**Site Specific Environmental
Authority Application for
Petroleum Lease (PL) 1059 –
Towrie development**

**Response to Notice of
Information Request –
Application Reference No:
APP0072009/PL1059**

Figure 1 Produced water process flow diagram

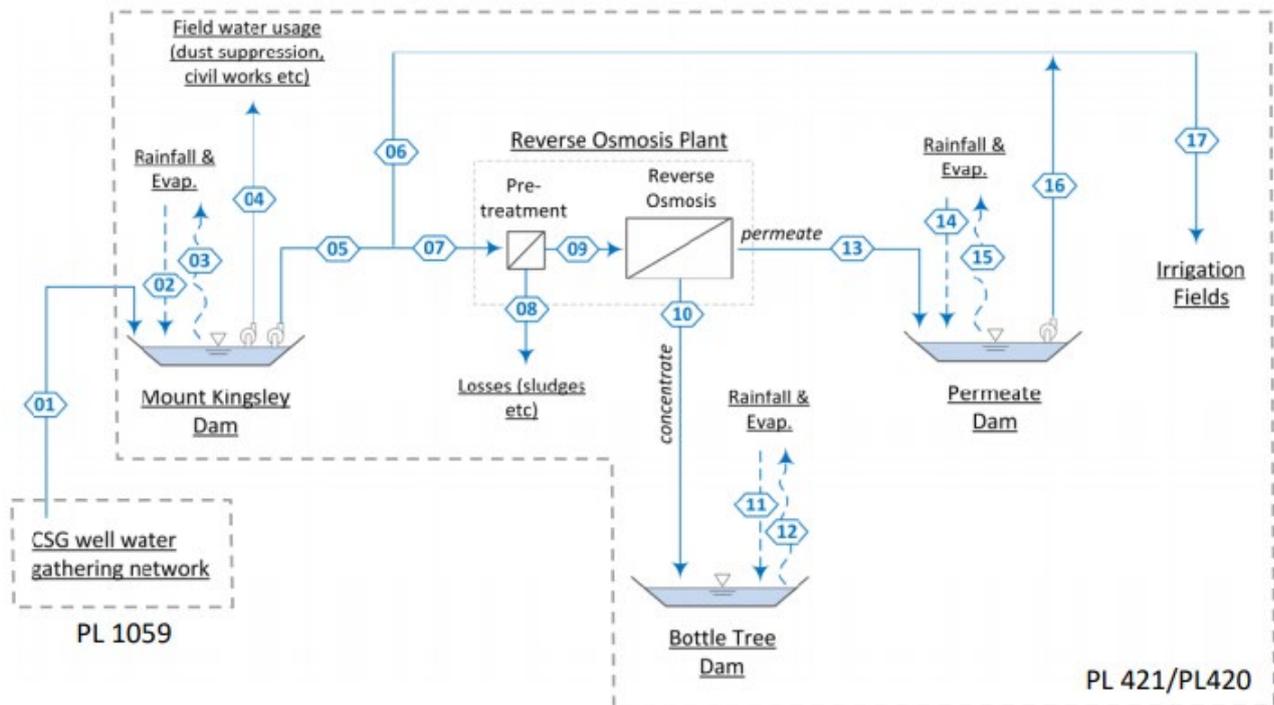
1. *The application states that produced water will be sent to PL421 for storage and management as authorised under EPPG00928713 however there does not appear to be a water treatment facility authorised within PL421 under this EA. Please confirm whether produced water will be transported and managed under the water treatment facilities authorised under EPPG00928713 which are located in PL100 and PL232 or at a separate water treatment facility.*

2. *Provide additional information on the proposed management of produced water including:*
 - a. *Expected volume to be transferred to adjacent water facilities*

- b. *Expected volume to be released to the environment within neighbouring tenures and the location of the release*
 - c. *expected volume to be used onsite for beneficial reuse*

- d. *expected volume of CSG water following treatment*
 - e. *expected volume of concentrated waste streams including brine from the activity*
 - f. *predicted volumes of treated CSG water to be reused/recycled, disposed of or released into the environment.*

Figure 1 presents the indicative water management process for the proposed activities. It includes well water gathering and onsite use within PL1059, with treatment and beneficial reuse off PL1059.

- The majority of produced water from PL1059 will be transferred to existing water management facilities on PL421. The peak water production for the project is predicted to occur in Year 7 of the project with a peak rate of 2.2 ML/day.

All water transferred to PL421 would be managed in accordance with the conditions of EA EPPG00928713. Water from PL1059 will be mixed with produced water generated under the FAPA EA and managed in accordance with existing practices. As previously mentioned this includes beneficial reuse for irrigation and other onsite activities.
